## **PRELIMINARY** STORMWATER SITE PLAN

### **Mullan Short Plat**

City File No. P-21-0067

January 11, 2022

### Figure 5.2.1

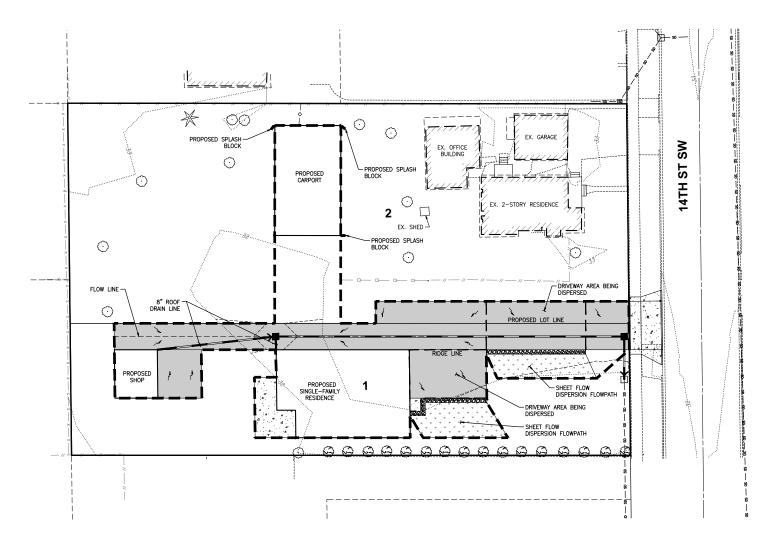
The WWHM calculation on page 36 speaks to a bypass basin. Show this on the basin map. [prelim drainage plan, pg 27]
